PCN/18/009/C+N-US

Product range: Han / Han C

Title: Han C female contacts – New shape

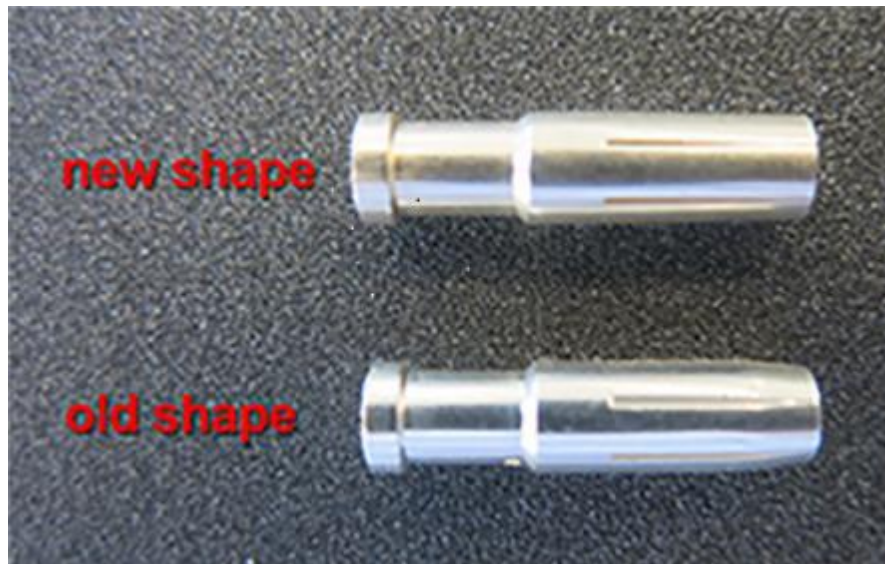
We are glad to inform you about a product modification to the Han®C female contacts. The shape of the Han®C female contacts in the mating area will change from a “tulip” design to a “cone” design as showed in the picture below.

The benefit of this modification is that it significantly reduces the mating and unmating force between the male and femal contacts.
